Subject: Issuance of Amendment No. 14 to Facility Operating License
NPF-35 and Amendment No. 6 to Facility Operating License
NPF-52 - Catawba Nuclear Station, Units 1 and 2

These amendments modify Technical Specifications related to application of a positive moderator temperature coefficient and to reflect the Cycle 2 refueling for Unit 1.

AMENDMENT NO. 14 TO FACILITY OPERATING LICENSE NPF-35 -
CATAWBA NUCLEAR POWER STATION, UNIT 1
AMENDMENT NO. 6 TO FACILITY OPERATING LICENSE NPF-52 -
CATAWBA NUCLEAR POWER STATION, UNIT 2

FIGURE 3.1-1a

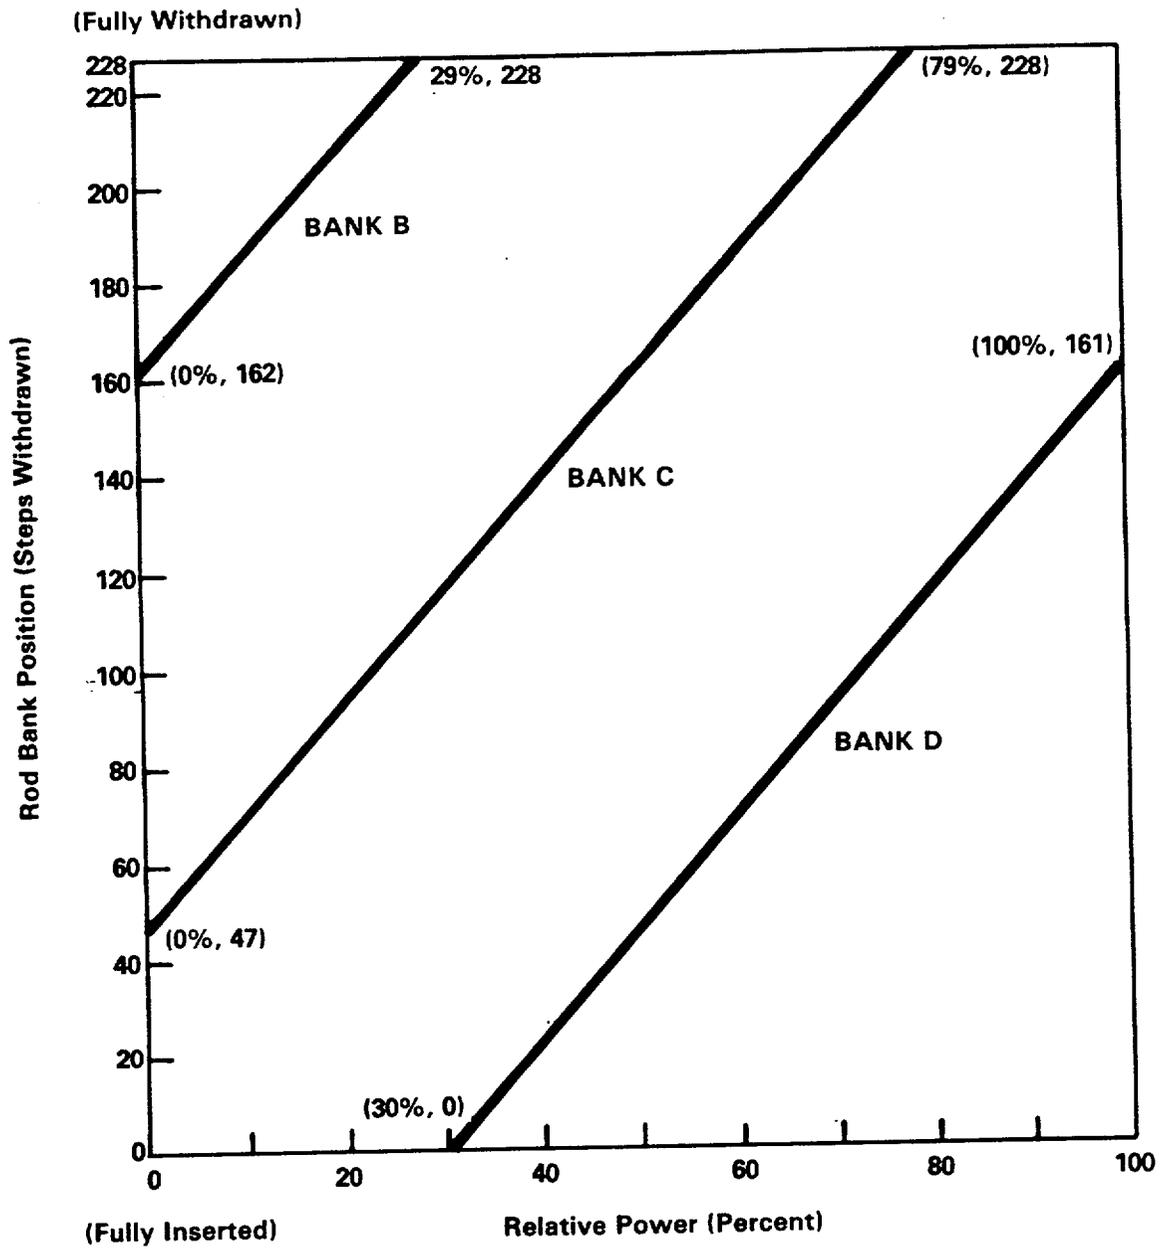
- a. Restore the control banks to within the limits within 2 hours,
or
- b. Reduce THERMAL POWER within 2 hours to less than or equal to that fraction of RATED THERMAL POWER which is allowed by the bank position using the above figure, or
- c. Be in at least HOT STANDBY within 6 hours.

The RSE provides a table of Cycle 2 kinetics characteristics which are compared with the current limits based on previously approved accident analyses. The RSE also provides a table showing the results of the calculated Cycle 2 control rod worths and requirements at the most limiting condition during the cycle (end-of-life). These results include a standard 10% allowance for calculational uncertainty. From these results the staff concludes that sufficient control rod worth will be available to provide the required shutdown margin for Cycle 2 operation. Control rod insertion limits were increased for less than 100% power for Cycle 2. Since the required shutdown margin is maintained, the TS change proposed to reflect the increased insertion is acceptable.

FIGURE 3.1-0
 MODERATOR TEMPERATURE COEFFICIENT VS. POWER LEVEL

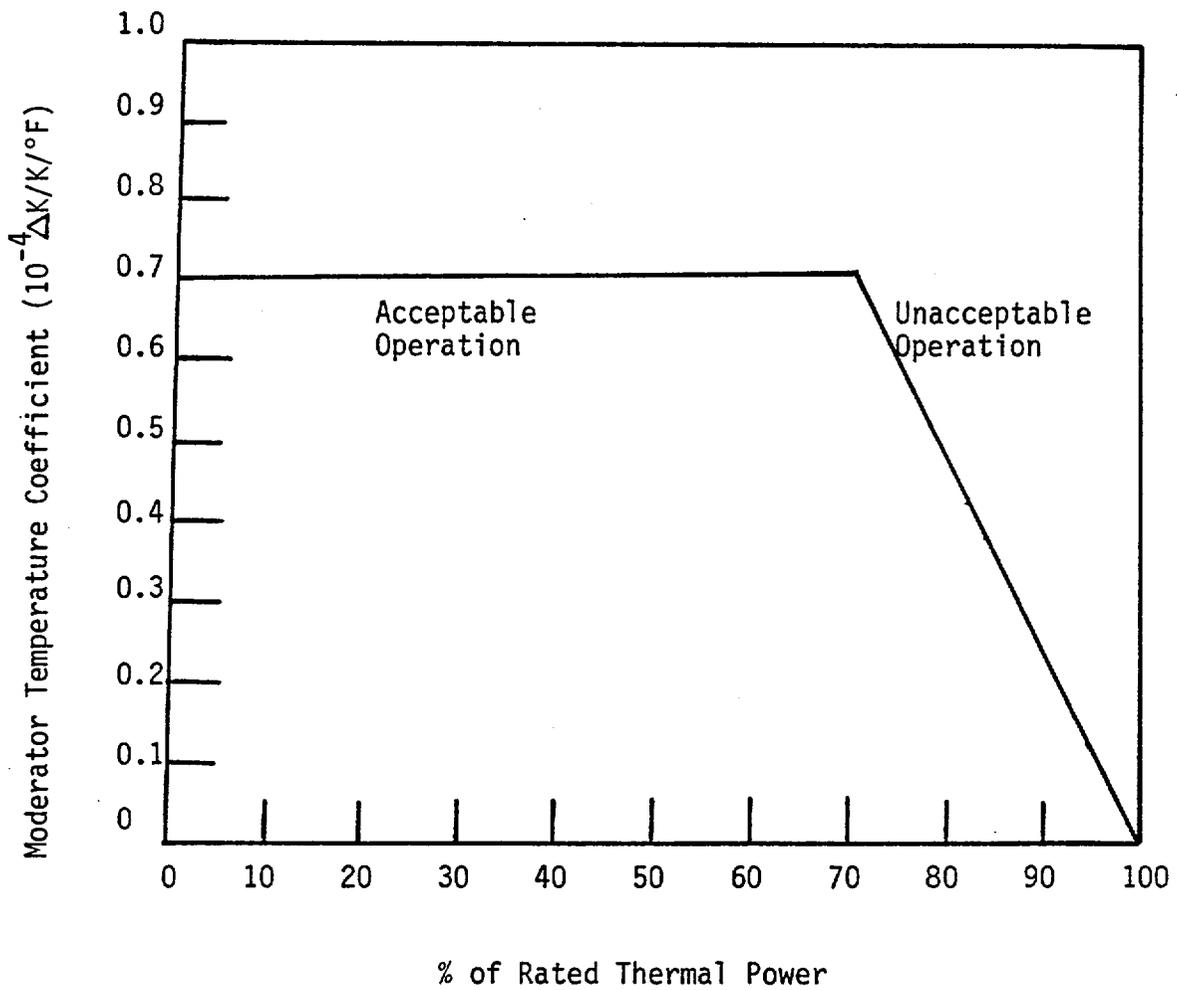
- a. Less positive than the limits shown in Figure 3.1-0;
- b. Less negative than $-4.1 \times 10^{-4} \Delta k/k/^\circ F$ for all the rods withdrawn, end of cycle life (EOL), RATED THERMAL POWER condition.

- a. With the MTC more positive than the limits shown in Figure 3.1-0, operation in MODES 1 and 2 may proceed provided:
 1. Control rod withdrawal limits are established and maintained sufficient to restore the MTC to less positive than the limits shown in Figure 3.1-0 within 24 hours or be in HOT STANDBY within the next 6 hours. These withdrawal limits shall be in addition to the insertion limits of Specification 3.1.3.6;

- a. The MTC shall be measured and compared to the limit of Figure 3.1-0 prior to initial operation above 5% of RATED THERMAL POWER, after each fuel loading; and
- b. The MTC shall be measured at any THERMAL POWER and compared to $-3.2 \times 10^{-4} \Delta k/k/^\circ F$ (all rods withdrawn, RATED THERMAL POWER condition) within 7 EFPD after reaching an equilibrium boron concentration of 300 ppm. In the event this comparison indicates the MTC is more negative than $-3.2 \times 10^{-4} \Delta k/k/^\circ F$, the MTC shall be remeasured, and compared to the EOL MTC limit of Specification 3.1.1.3b., at least once per 14 EFPD during the remainder of the fuel cycle.

By letter dated July 15, 1986 (Ref. 1), Duke Power Company (the licensee) made an application to amend facility operating licenses NPF-35 and NPF-52 for Catawba Nuclear Station Units 1 and 2, respectively, to reflect the Cycle 2 refueling and related Technical Specification (TS) changes for Unit 1 and a TS change for both Units related to application of a positive Moderator Temperature Coefficient (MTC). A second letter (Ref. 2) provided some TS pages inadvertently omitted from Reference 1. The proposed TS change applicable to both Units consists of increasing the allowable positive MTC and most negative EOL MTC. The previous TS allowed a +5 pcm/°F MTC at power levels up to 70% power, and 0 at power levels about 70%. The proposed revision would allow an MTC of +7 pcm/°F up to 70%, decreasing linearly above 70% power to 0 pcm/°F at 100% power.

The incidents reanalyzed, with two exceptions, used a +7 pcm/°F moderator temperature coefficient, assumed to remain constant for variations in temperature. This is conservative, since the proposed change will require the coefficient to ramp to zero at full power. The two exceptions are the rod ejection and the rod withdrawal from subcritical accidents, for which the computer model cannot accept a constant coefficient. The coefficient decrease which occurred during the transients was less than the proposed change, which is acceptable. The transients reanalyzed and their results are:

Since the reanalysis of the affected plant transients does not result in exceeding any of the fuel limits or safety limits specified in the previously approved reference or FSAR analyses, the staff concludes the analysis supporting operation with a positive moderator temperature coefficient of +7 pcm/°F up to 70% power, and decreasing linearly from this to 0 pcm/°F at full power will not pose an undue risk to the health and safety of the public and is therefore acceptable. The analysis is applicable to both Catawba Units 1 and 2, and therefore the proposed revision of the TS to incorporate the MTC for both Units is acceptable.

FIGURE 3.2-1a
AXIAL FLUX DIFFERENCE LIMITS AS A FUNCTION OF RATED THERMAL POWER (UNIT 1)

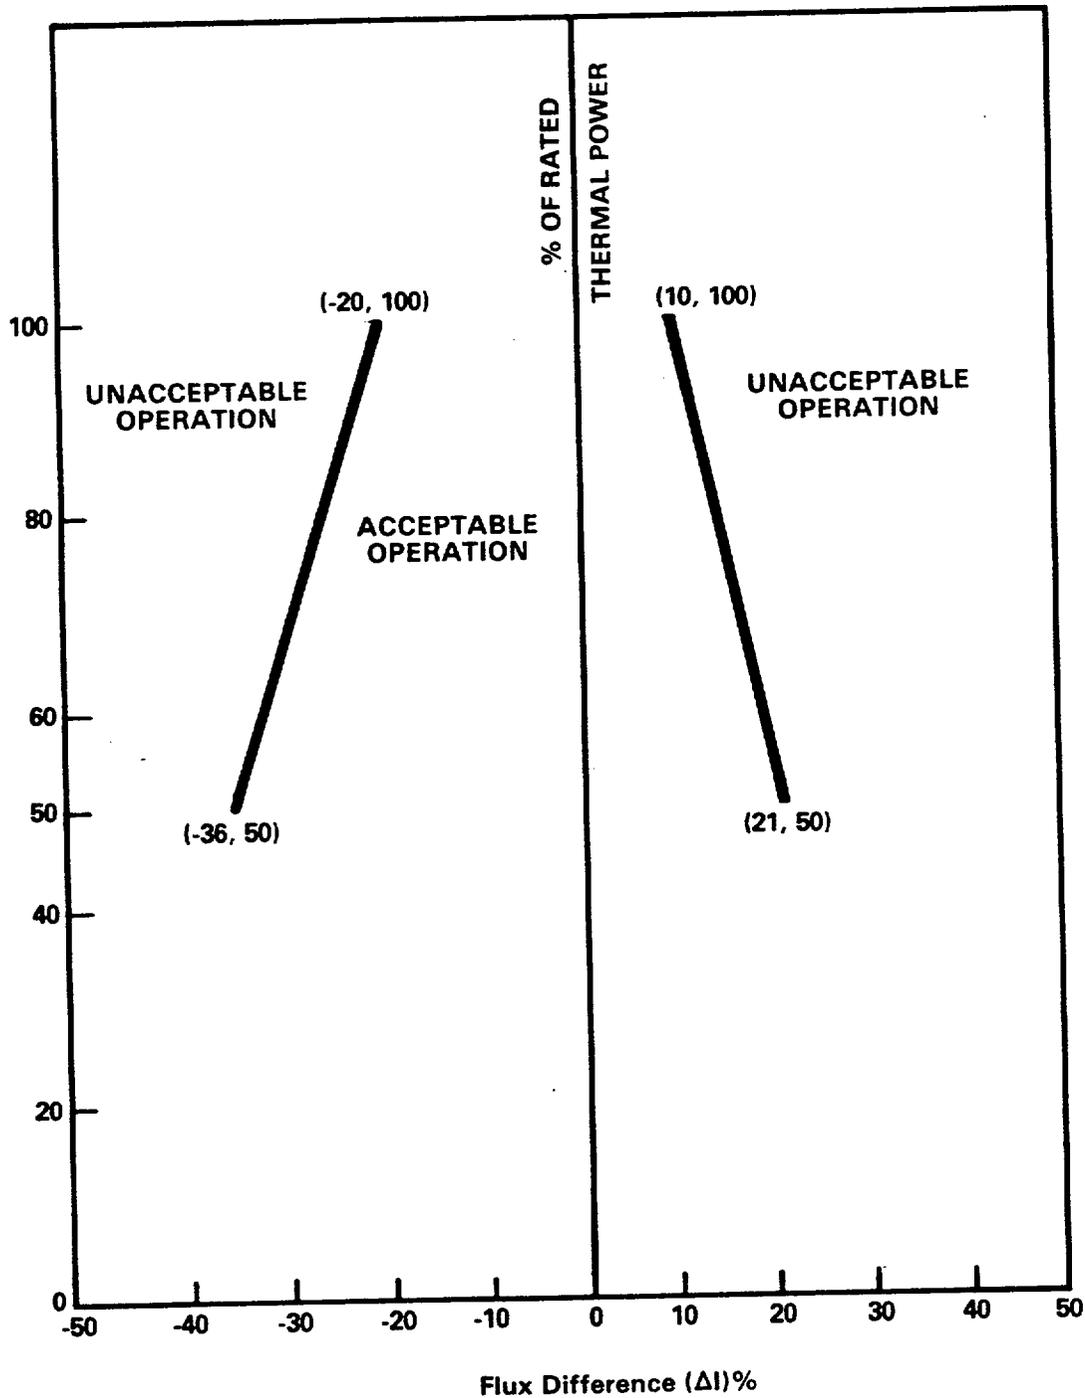
- a. the allowed operational space defined by Figure 3.2-1a for RAOC operation, or
- b. within a $\pm 3\%$ target band about the target flux difference during baseload operation.

- a. For RAOC operation with the indicated AFD outside of the Figure 3.2-1a limits,
 1. Either restore the indicated AFD to within the Figure 3.2-1a limits within 15 minutes, or

- c. THERMAL POWER shall not be increased above 50% of RATED THERMAL POWER unless the indicated AFD is within the Figure 3.2-1a limits.

The power distributions produced by the cycle-specific RAOC analysis were analyzed for normal operation and Condition II events. Limits on the allowable operating flux difference as a function of power level from these considerations were found to be less restrictive than those resulting from LOCA F_0 considerations. The Condition II analyses generate DNB core limits and resultant Over-Temperature Delta-T setpoints. These generated a change to the $F(\Delta I)$ function in the TS. The change is acceptable because it results from cycle-specific calculations using approved methods (Refs. 6 and 7). Therefore, the staff concludes that the Cycle 2 thermal-hydraulic analysis is acceptable.

FIGURE 3.2-2

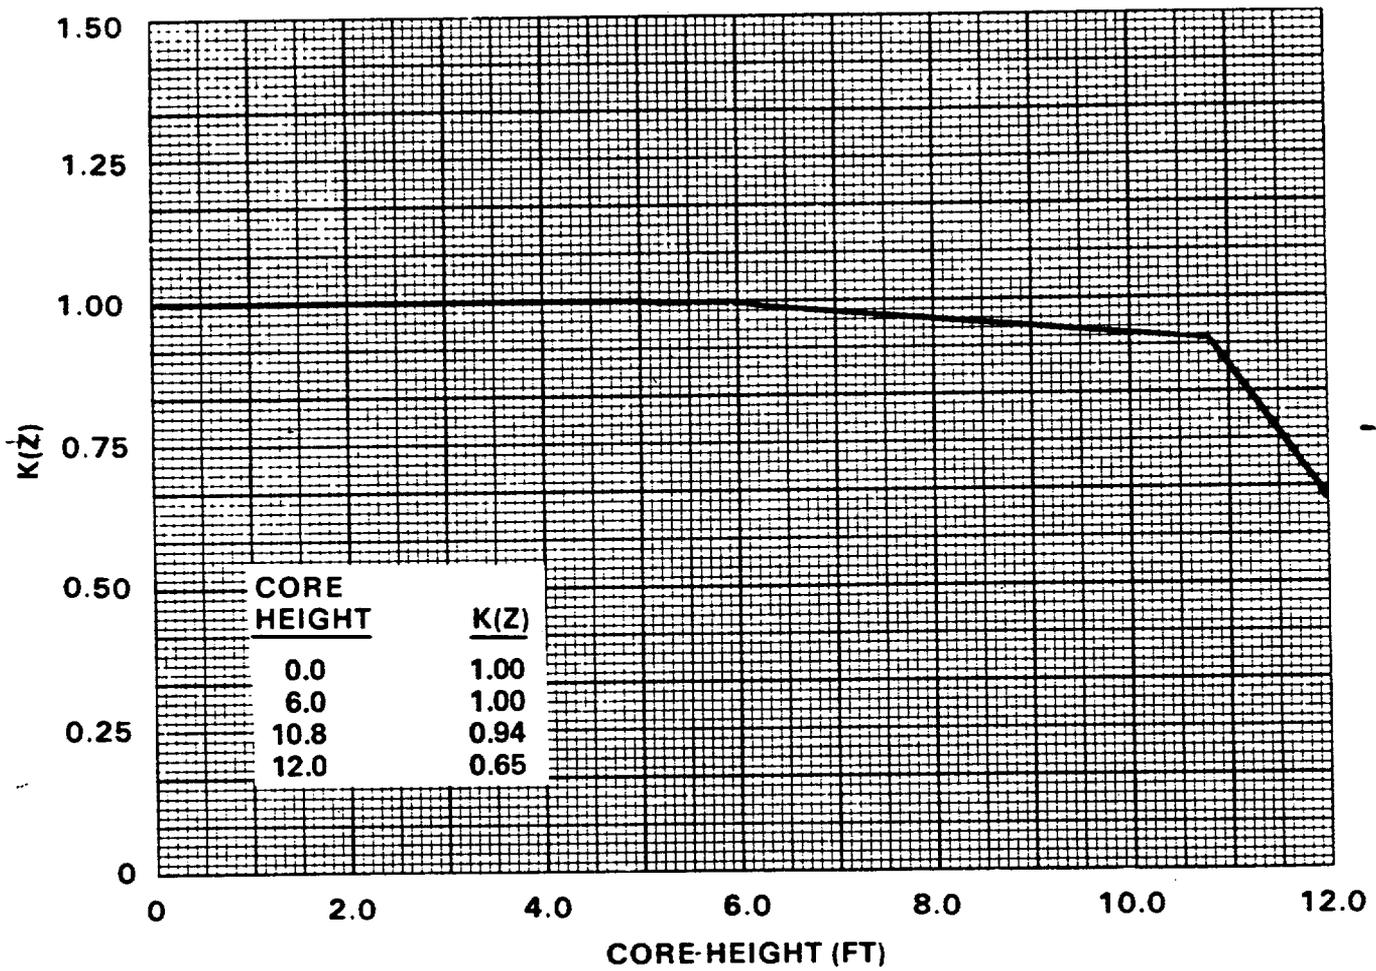
where $F_Q^M(z)$ is the measured $F_Q(z)$ increased by the allowances for manufacturing tolerances and measurement uncertainty, 2.32 is the F_Q limit, $K(z)$ is given in Figure 3.2-2, P is the relative THERMAL POWER, and $W(z)$ is the cycle dependent function that accounts for power distribution transients encountered during normal operation. This function is given in the Peaking Factor Limit Report as per Specification 6.9.1.9.

where: $F_Q^M(z)$ is the measured $F_Q(z)$ increased by the allowances for manufacturing tolerances and measurement uncertainty. The F_Q limit is 2.32. $K(z)$ is given in Figure 3.2-2. $W(z)_{BL}$ is the cycle dependent function that accounts for limited power distribution transients encountered during base load operation. The function is given in the Peak Factor Limit Report as per Specification 6.9.1.9.
